REMARKS

Attached hereto is a marked-up version of the changes made to the claims by the current amendment. The attached Appendix is captioned "Version with markings to show changes made."

As a preliminary matter, with regard to the drawings, Applicants have included herewith a marked-up copy of Figure 4, with the proposed changes in red. Approval of the proposed drawing changes is respectfully requested.

FIG. 4

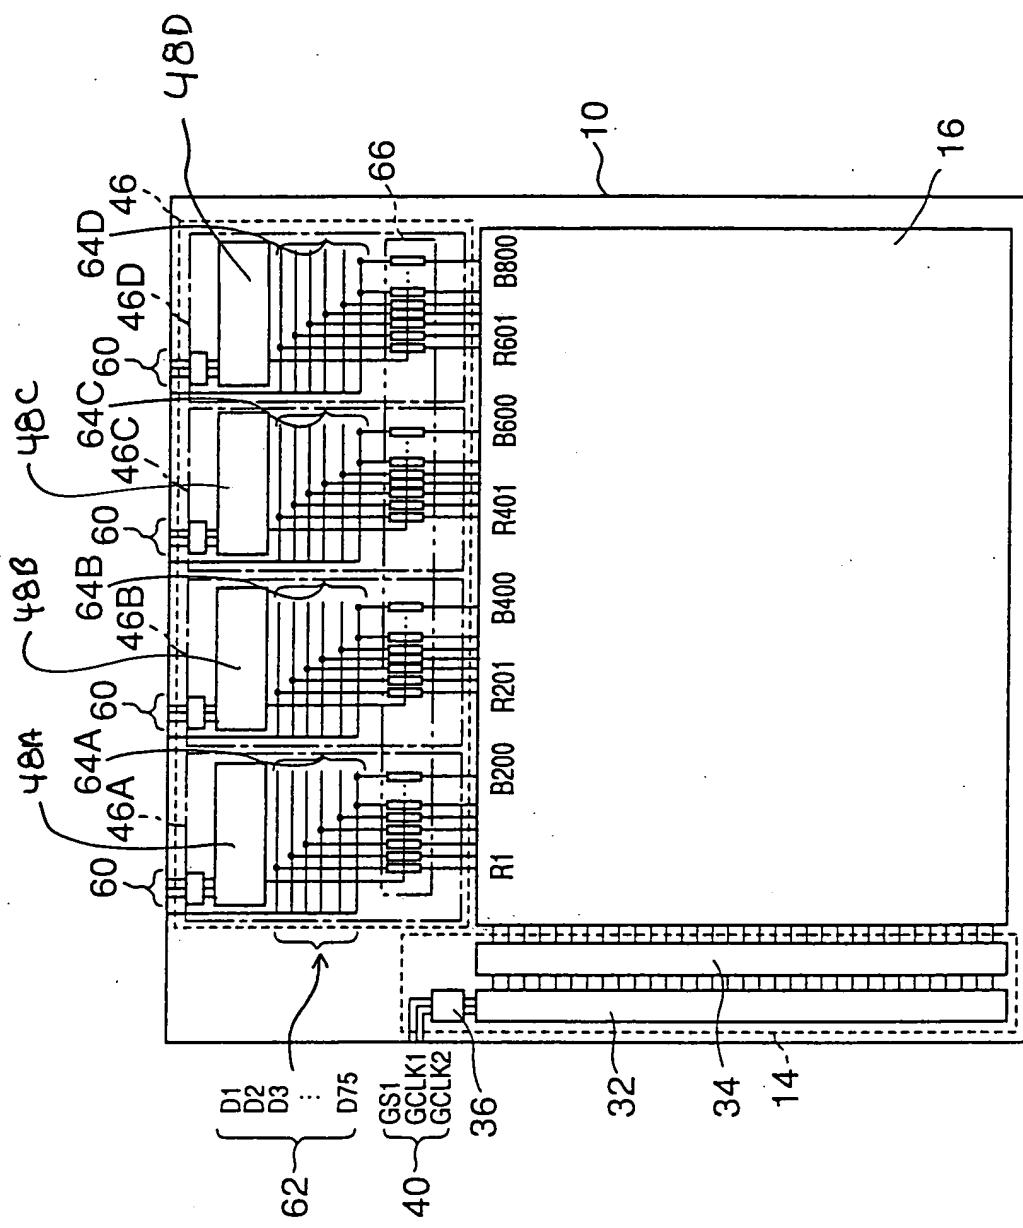
Applicants’ Figure 4 shows one embodiment of the invention defined in Claim 16 in which the data driver is divided into four blocks 64A, 64B, 64C and 64D. As can be seen in Figure 4, all four of these blocks are “arranged side by side along a single edge of the liquid crystal display panel.”
